R13WM

Adhesive Omitted at Transit Sliding Window Body Panel Joints

Models Affected: 2007 thru 2014 All American and Vision with optional Transit Sliding Windows

Fig. 3

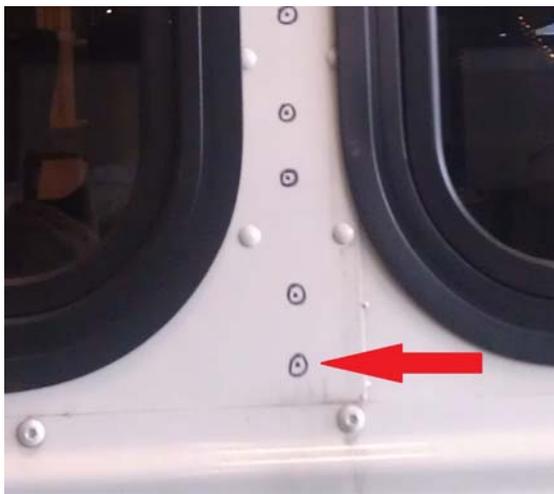
3. Near the top of the bus are four rivets that are close together. Make a mark for one rivet in the center of these four existing rivet. (Fig. 3)
4. Mark an additional rivet 1.33" (1" and 11/32") below the bottom rivet. (Fig. 4)
5. Using a 17/64" drill bit, install provided drill stop at 1/2" (0.50). The drill stop must be used to prevent possible damage to wires in bow cavities. Be sure holes are centered between rivets. (Fig. 5) Take extra care in drilling through reflective tape where applicable.
6. Install part number #01854397 Rivet, Blind, .25 Dia, .38 grip, in each hole drilled using a rivet gun/tool. (Fig. 5) Be sure to use the rivets painted Exterior Fleet White.
7. Touch up each rivet with the provided Exterior Fleet White touch-up paint.
